CITY OF PLACERVILLE PUBLIC WORKS

CONTRACT CHANGE ORDER MEMORANDUM

Western Placerville Interchanges Phase 1B

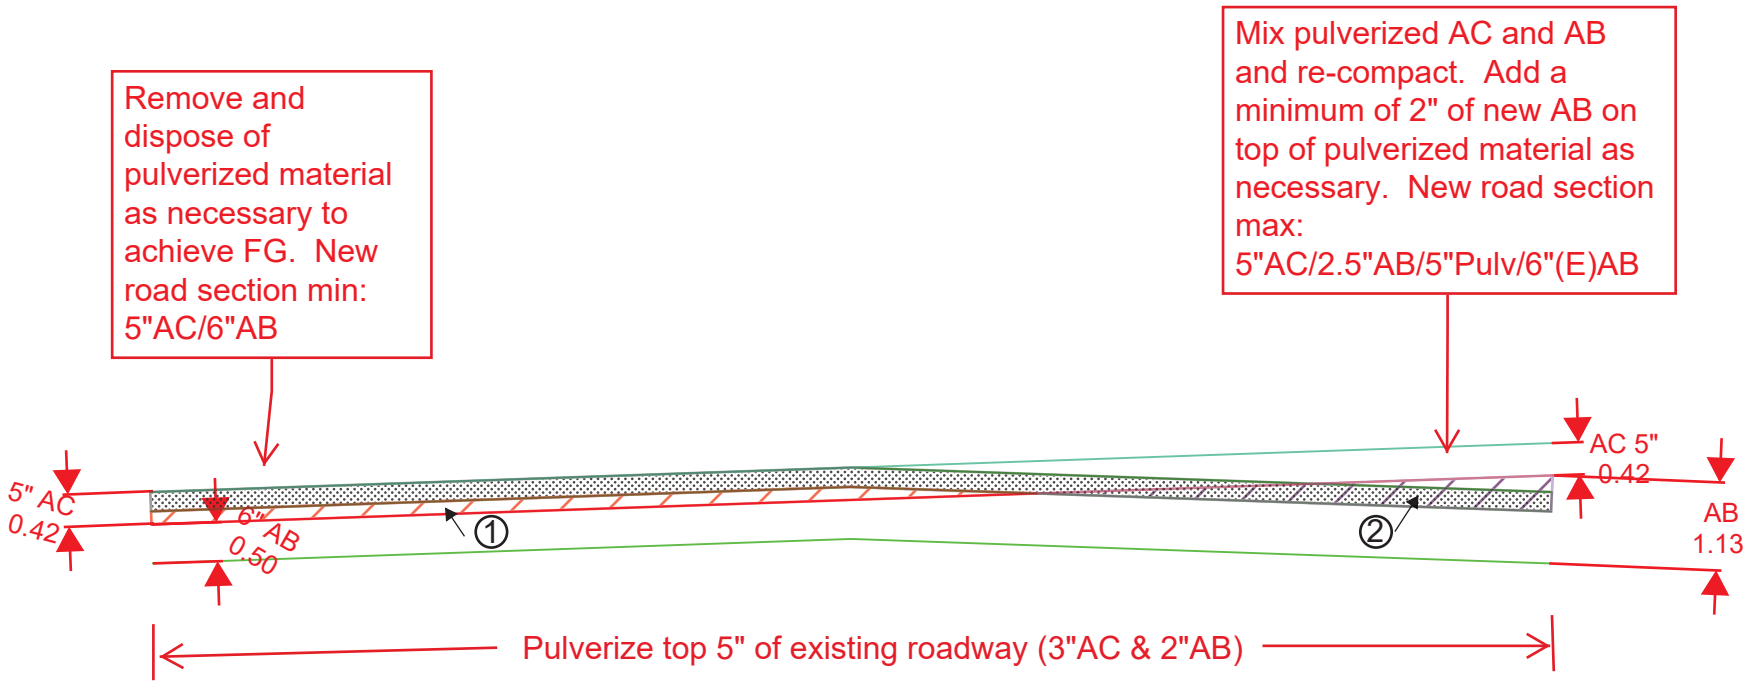
1. Eliminate HMA from sta 57+68 to sta 61+00.
2. Eliminate Cold Plane Asphalt from sta 57+68 to sta 61+00.
3. Pulverize existing asphalt from sta 57+68 to sta 61+00 compact and place aggregate base. Pulverize material at a depth of 5" across the entire roadway. Remove and dispose of pulverized material to a depth sufficient to provide either placement of new HMA on existing AB or a minimum of 2" of AB between the new HMA and pulverized material.
4. Place a minimum of .4' of HMA from sta 57+68 to sta 61+00.

Please proceed with VECP #1 as outlined in the attached. As we discussed, please pulverize material at a depth of 5" across the entire roadway. You must remove and dispose of pulverized material to a depth sufficient to provide either placement of new HMA on existing AB or a minimum of 2" of AB between the new HMA and pulverized material. Please see attached exhibit for further clarification. The City anticipates a credit in the amount of $8,949.80 and we will begin processing a Change Order to that effect. Please let me know if you have any questions or comments regarding this response.

Field Change #3 – Exhibit

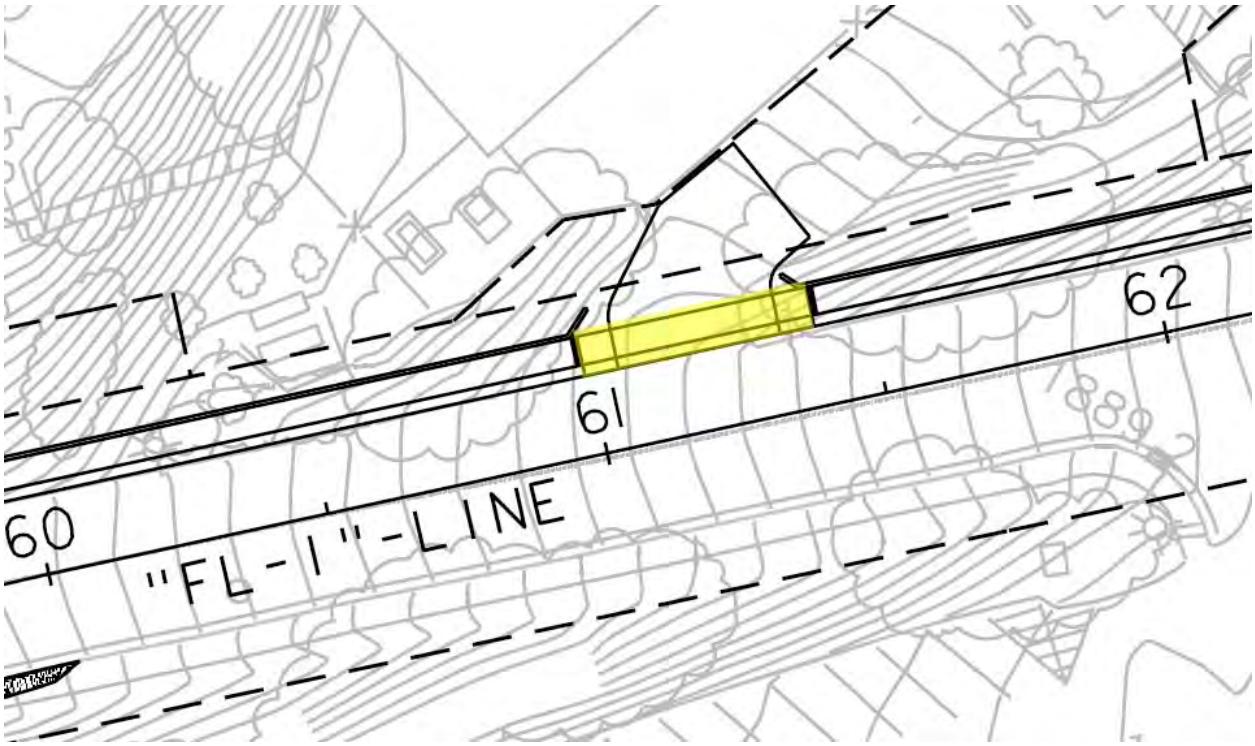
1. Over excavate an additional 12", install fabric and bring back up with AB at the Juvenile Hall and Superior Court Driveways per Field Change Directive #3.

Exhibit showing, in yellow, the approximate location of fabric to be installed.
Cost Breakdown of Field Change Directive which affects Bid Item #30.

Field Change #4 - Exhibit

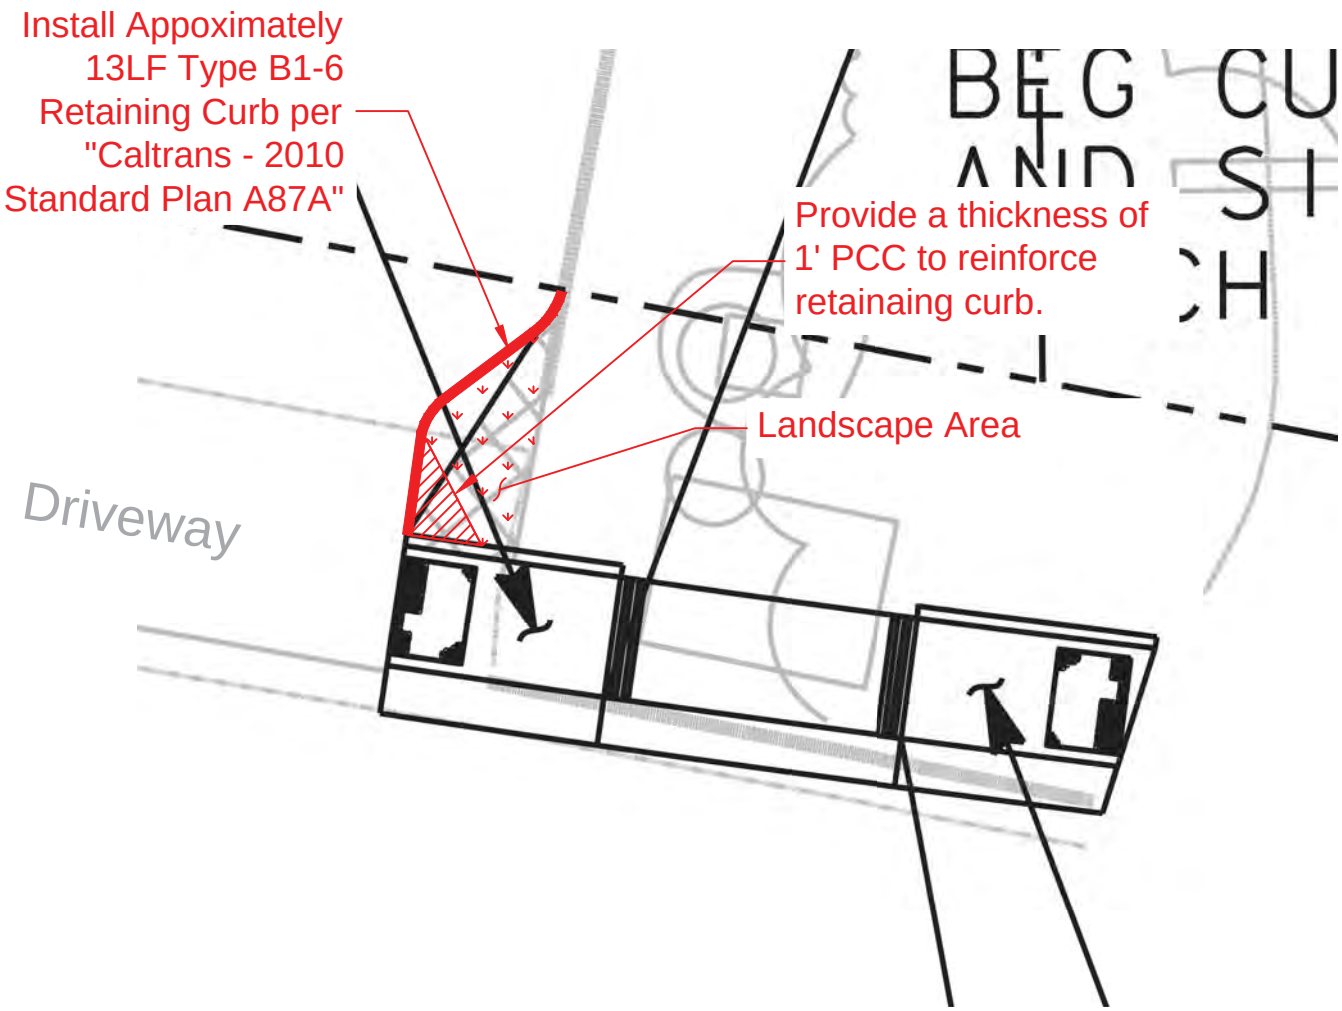
2. Install retaining Curb along the adjacent sawcut shown on FCD#4 exhibit to match the existing retaining curb along the driveway per Field Change Directive #4.

A retaining curb is needed to provide curb ramp protection at the ramp adjacent to the Denny's driveway.

FCD#4 exhibit with comments, in red, showing the approx. location of retaining curb to be installed.
Caltrans Standard Plan A87A "Curbs and Driveways."
Cost Breakdown of Field Change Directive.

Field Change #5 - Exhibit

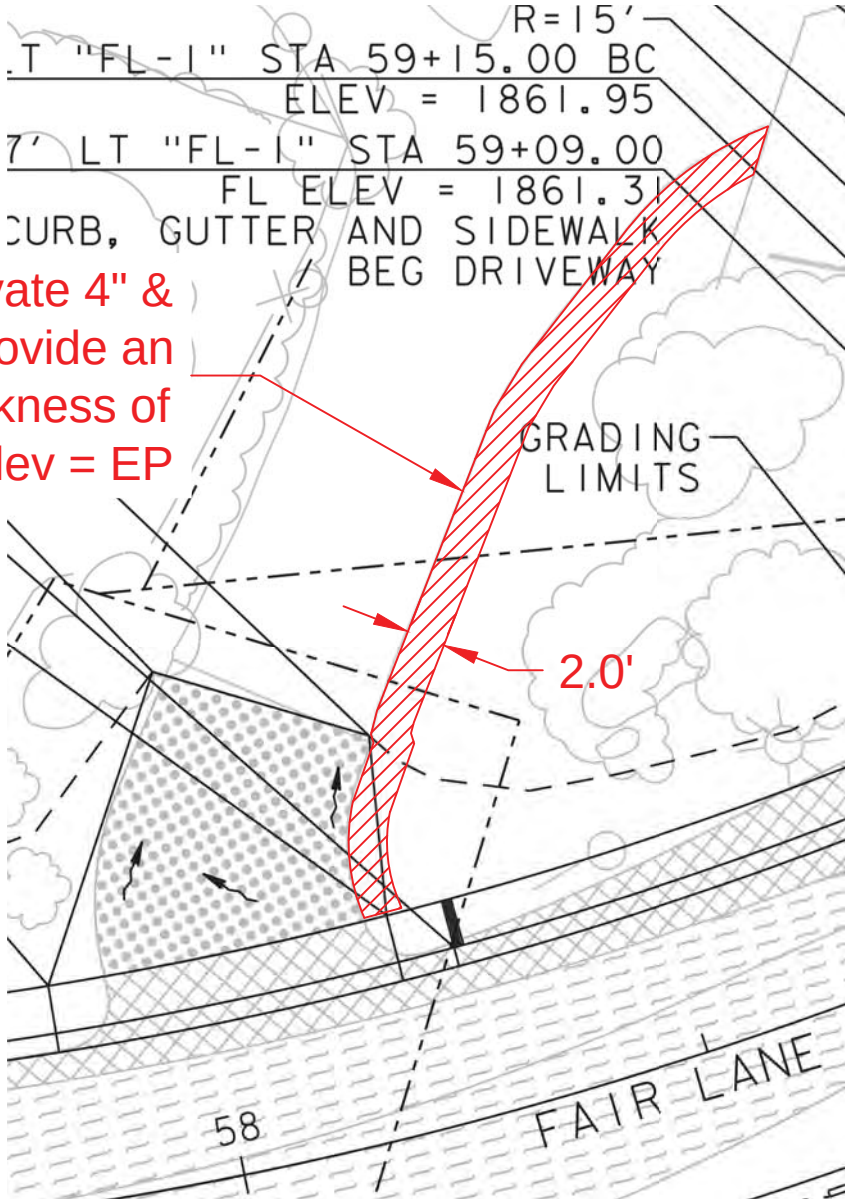
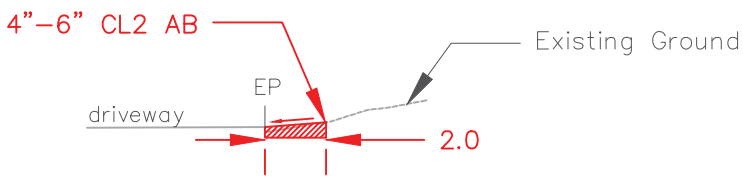
3. Excavate 2' wide along EP at the detour driveway shoulder approximately 60LF. Backfill to provide 4"-6" AB thickness to match EP per Field Change Directive #5.

Excavate 2' wide along EP at the detour driveway shoulder approximately 60LF. Backfill to provide 4"-6" AB thickness to match EP.

Field Change #5 Exhibit with comments showing, in red, the approximate location of excavation & backfill.
Cost Breakdown of Field Change Directive.

FCD #6 – TYPICAL RETAINING WALL SECTION

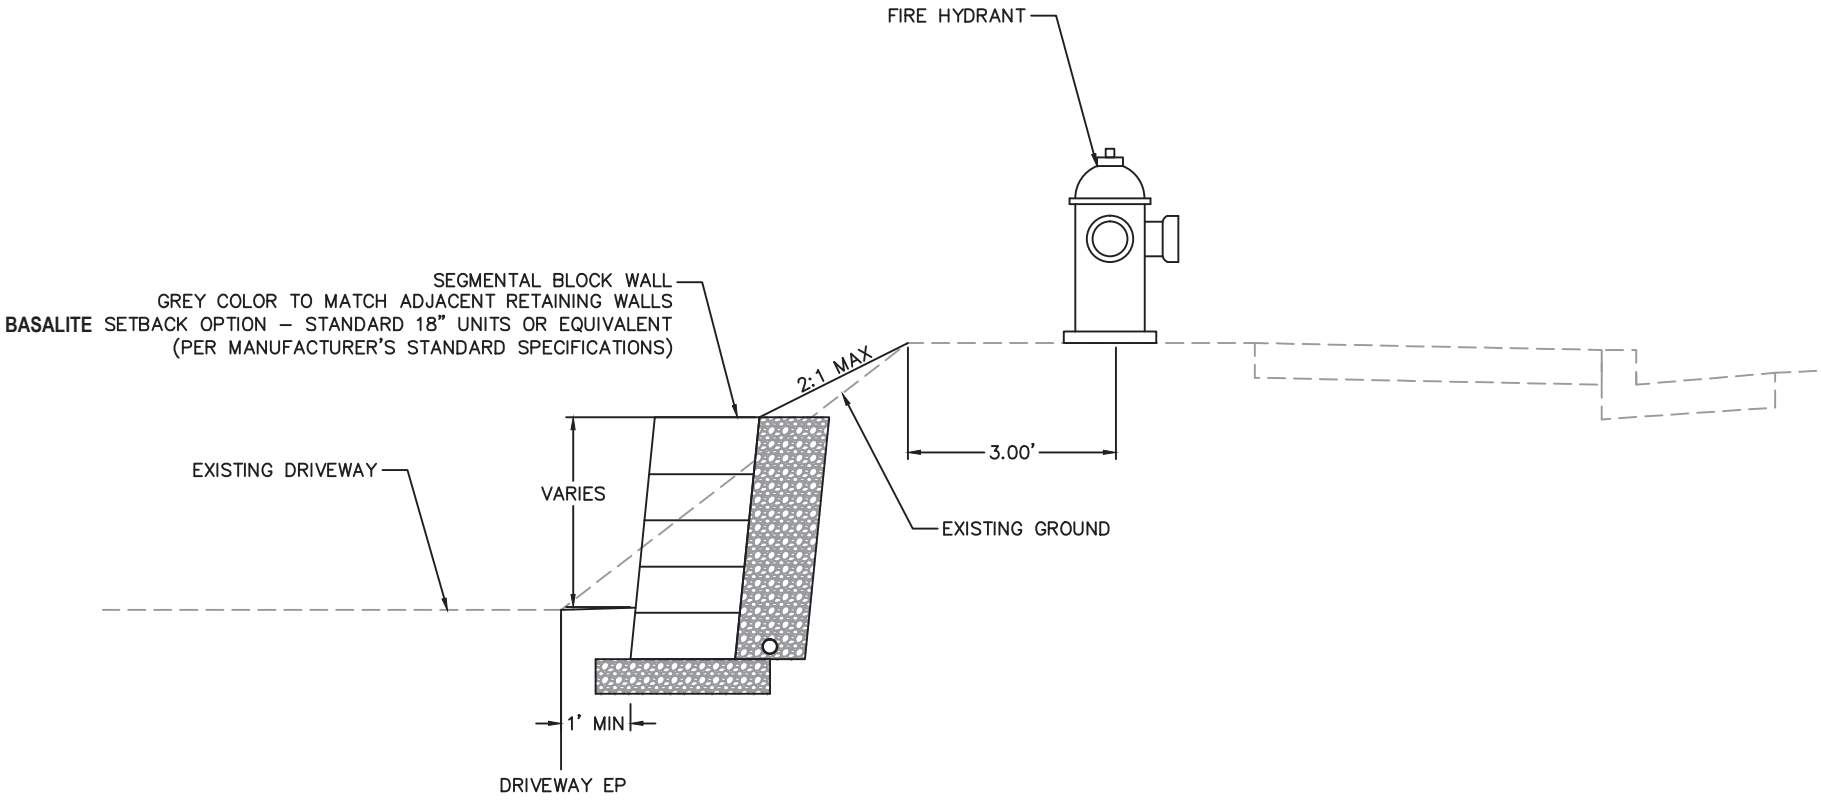
4. Construct 15LF of segmental block retaining wall at the Court Driveway to provide a flat pad for the fire hydrant as required by EID per Field Change Directive #6.

Retaining wall is required in order to provide a flat pad for the fire hydrant as required by EID.

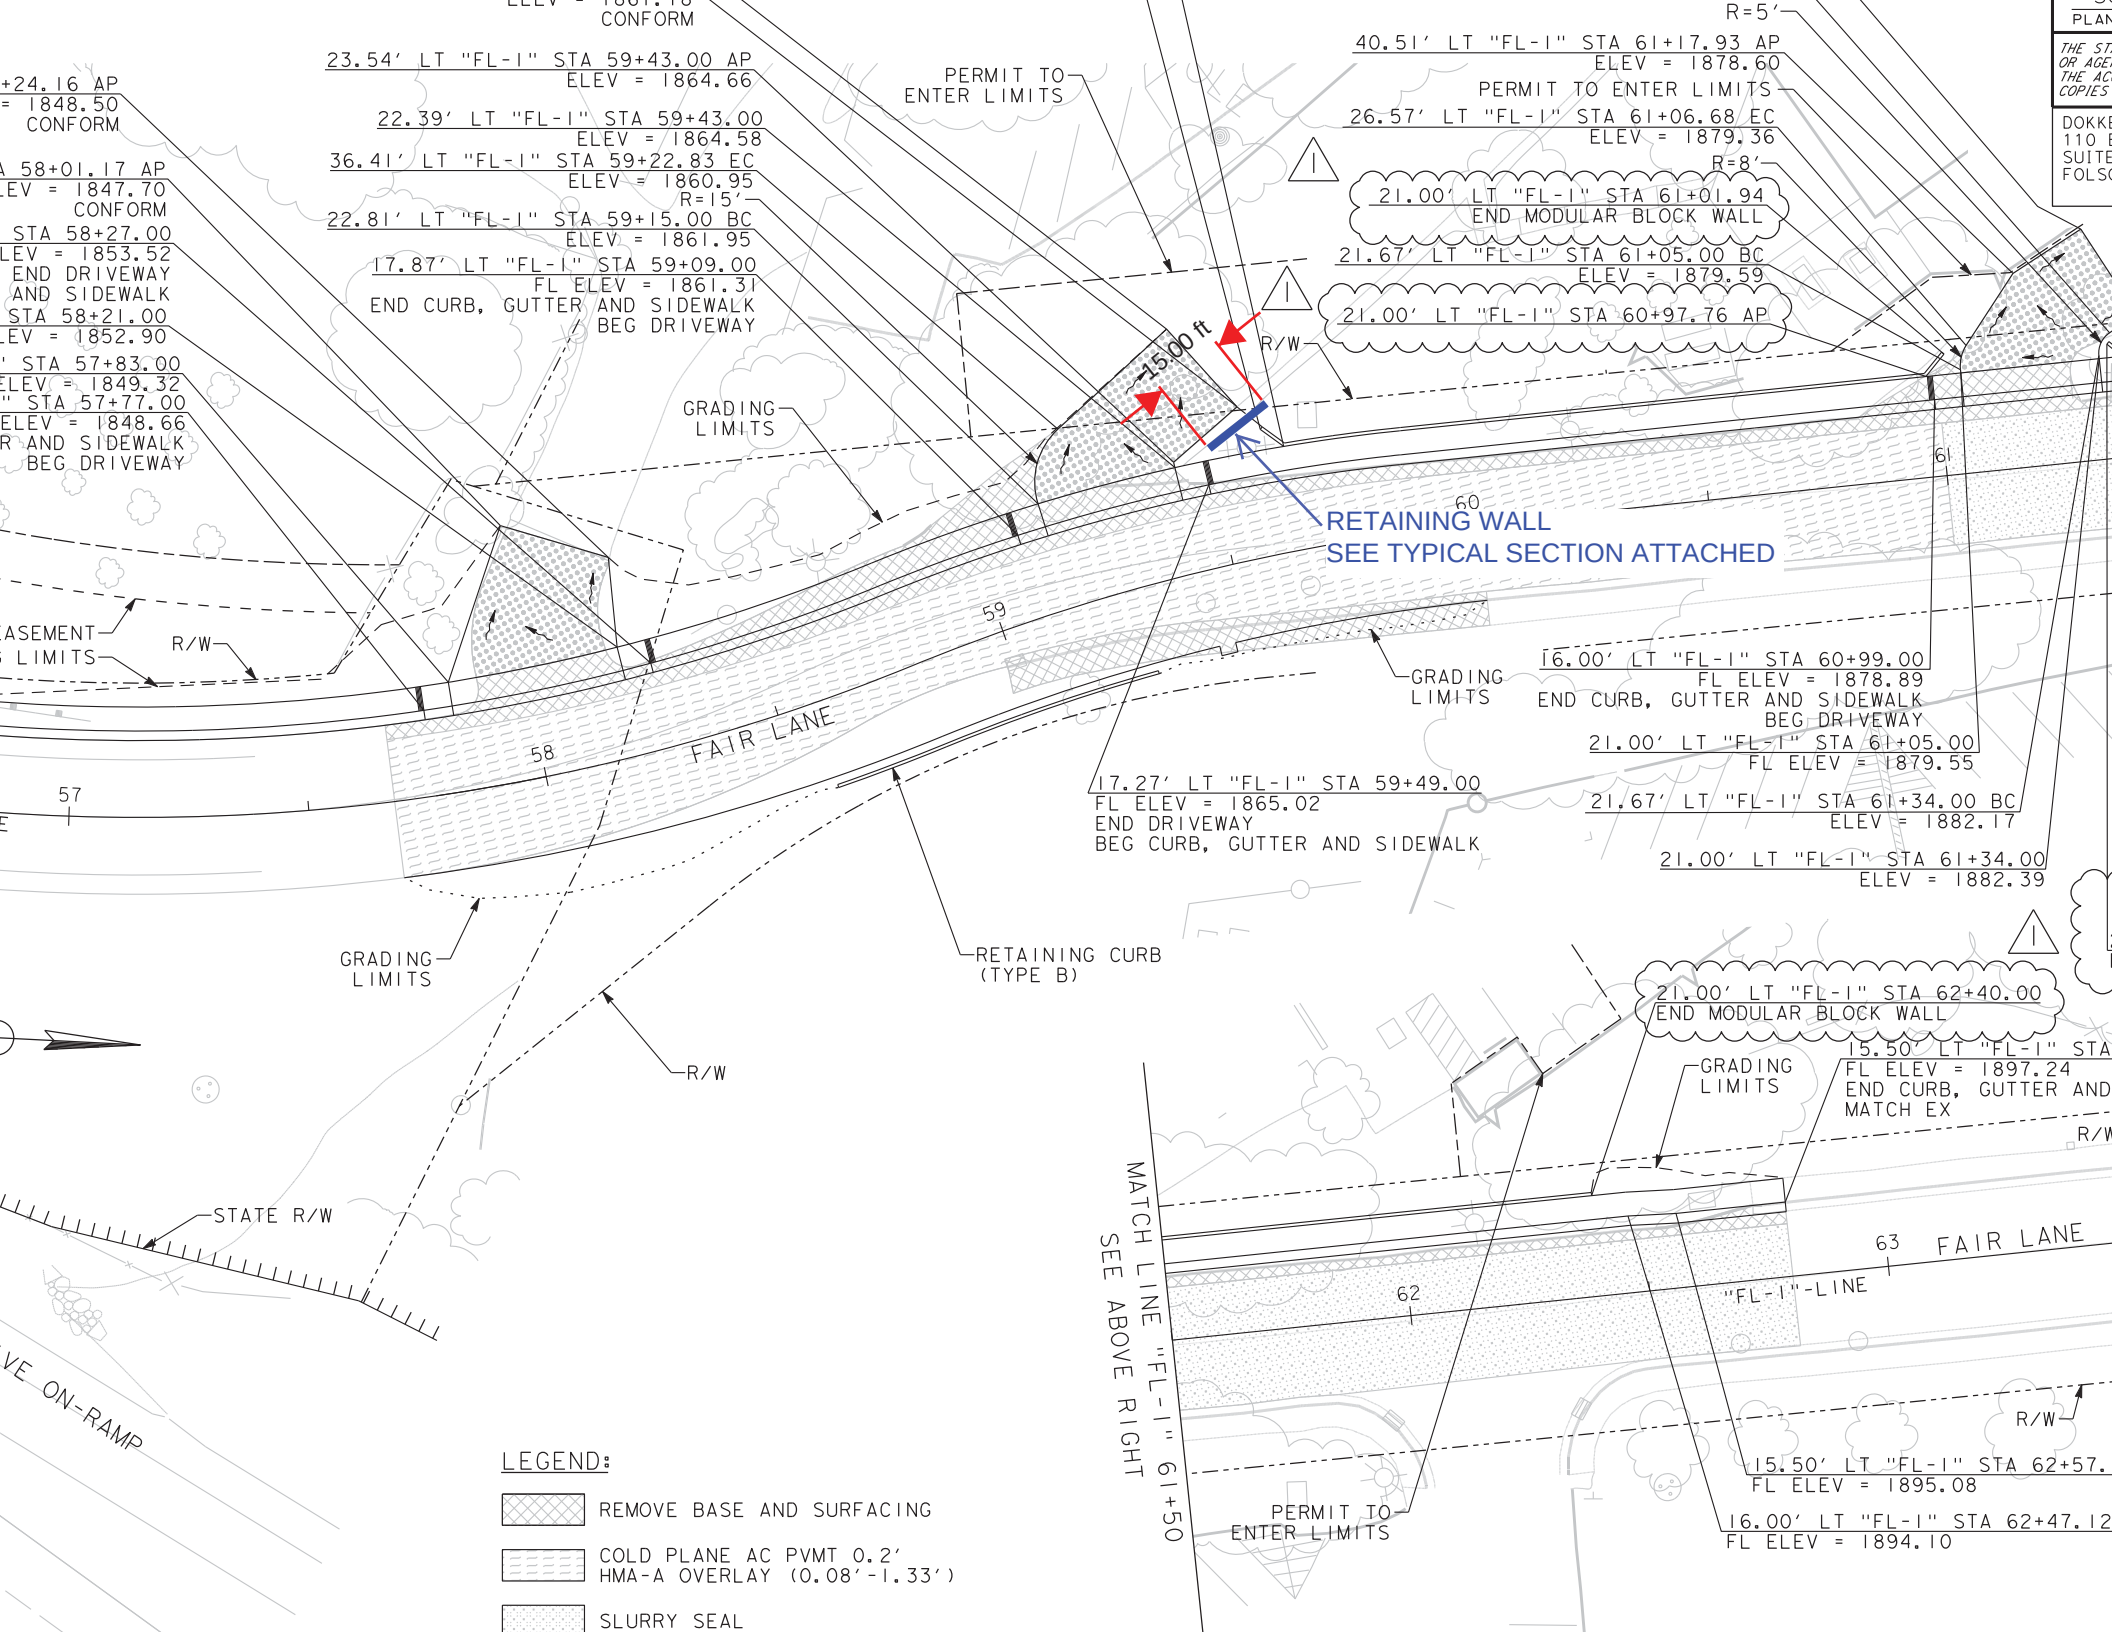
1 - Field Change #6 Typical Retaining Wall Section
2 - Plan Sheet C2 Markup with approximate location of Retaining Wall
3 - Basalite Geowall Pro - Max Height Gravity Wall Table
4 - Cost Breakdown
